Service Bulletin

Bulletin No.: 21-NA-140

Subject: Windshield Wiper Squeak on Passenger Side Wiper Pivot

Brand:	Model:	Model Year:		VIN:		Engine:	Transmission:
		from	to	from	to		
Chevrolet	Equinox	2021	2022			All	All
GMC	Terrain	2021	2022

4567730

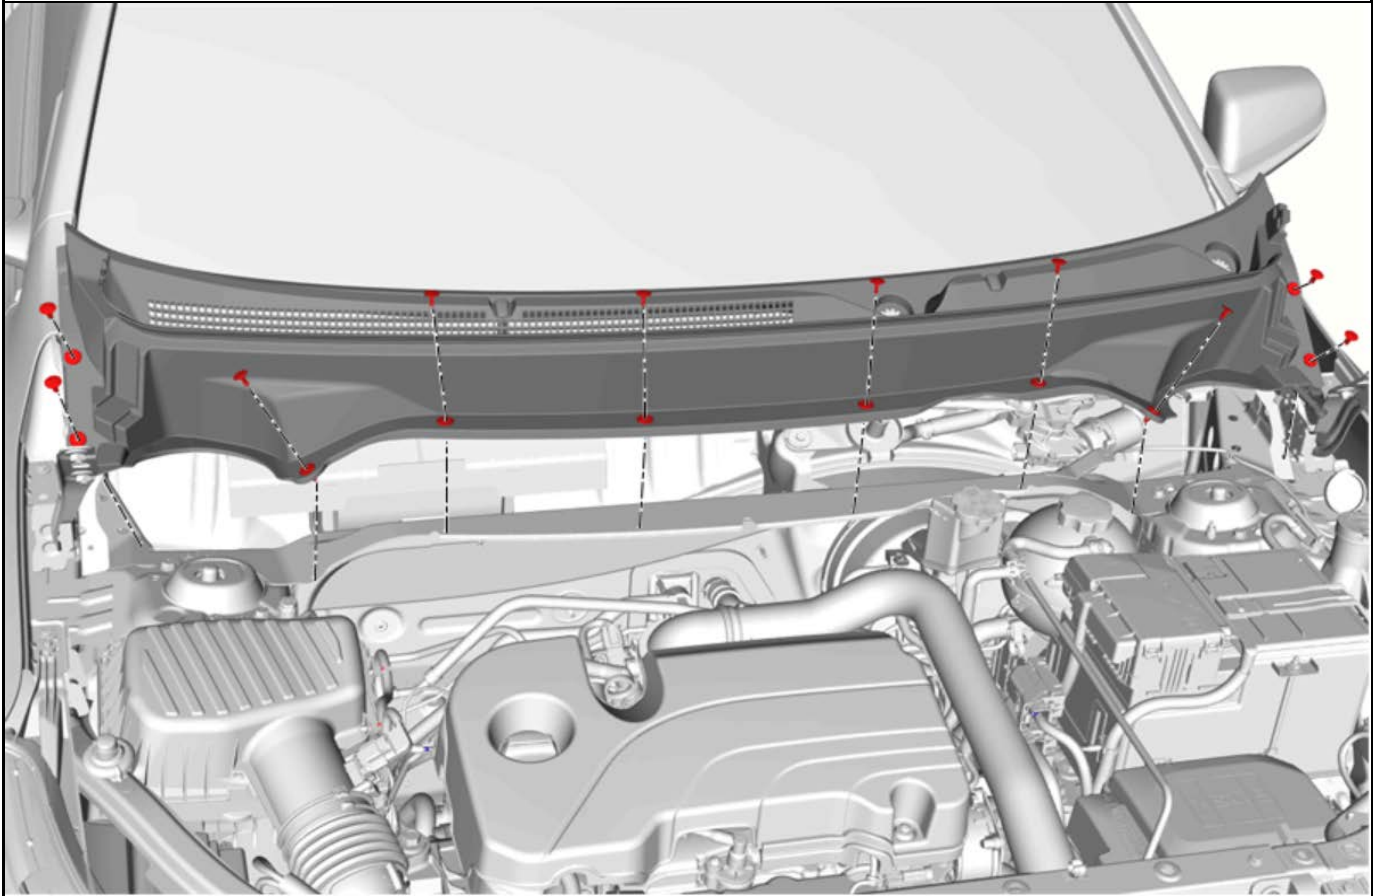
1. Remove the wiper arms and the air inlet panel from the vehicle. Refer to *Air Inlet Grille Panel Replacement*, in SI.

5866935

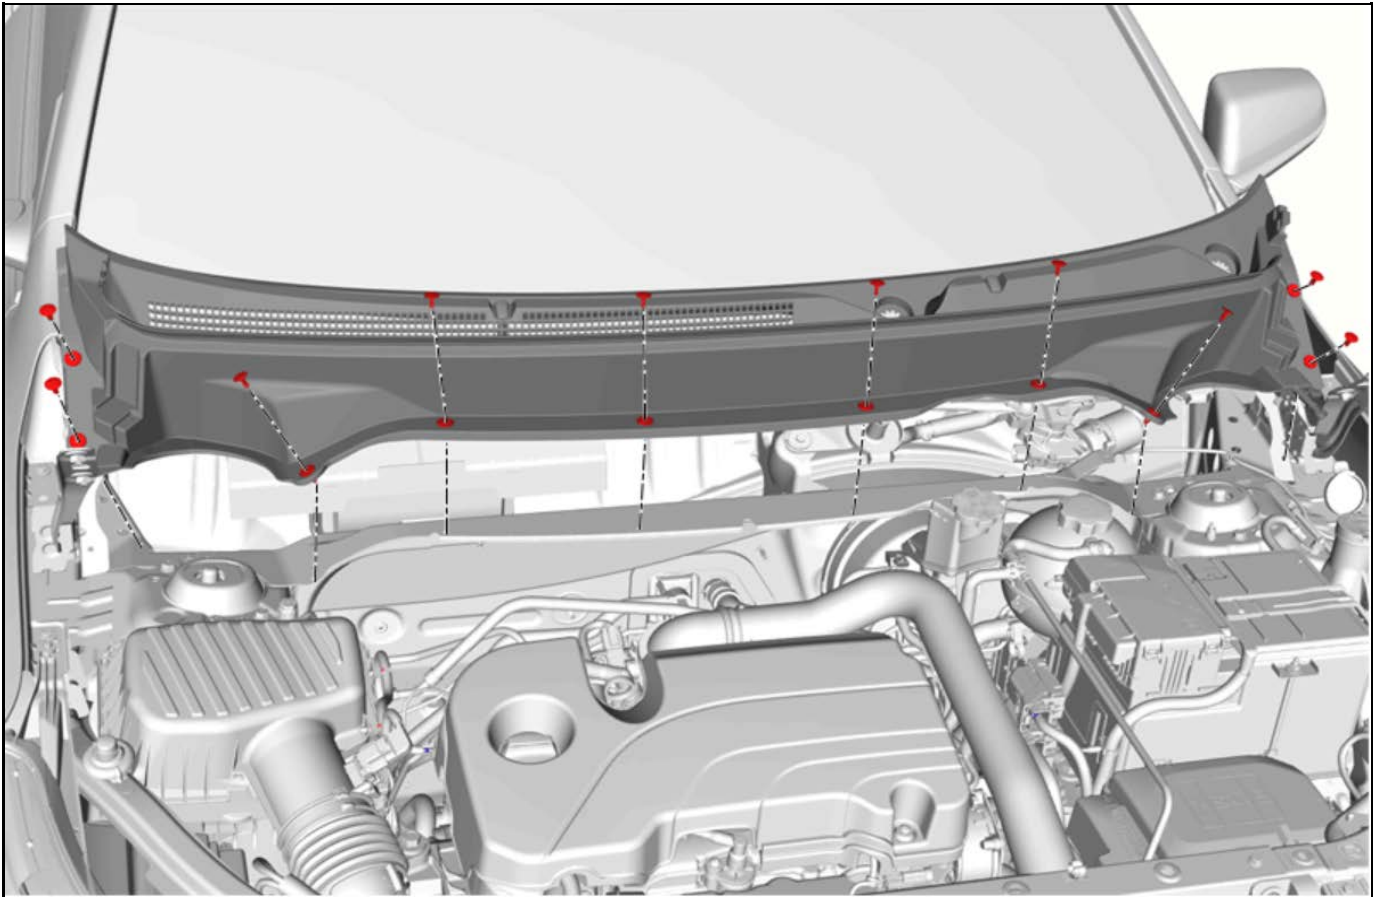
2. Add a short piece of self-adhering BRS tape, Kent Automotive KT13485, or equivalent, underneath the panel at the TWO hook locations closest to the passenger wiper arm hole.

Note: Cover the base of hook as shown above.
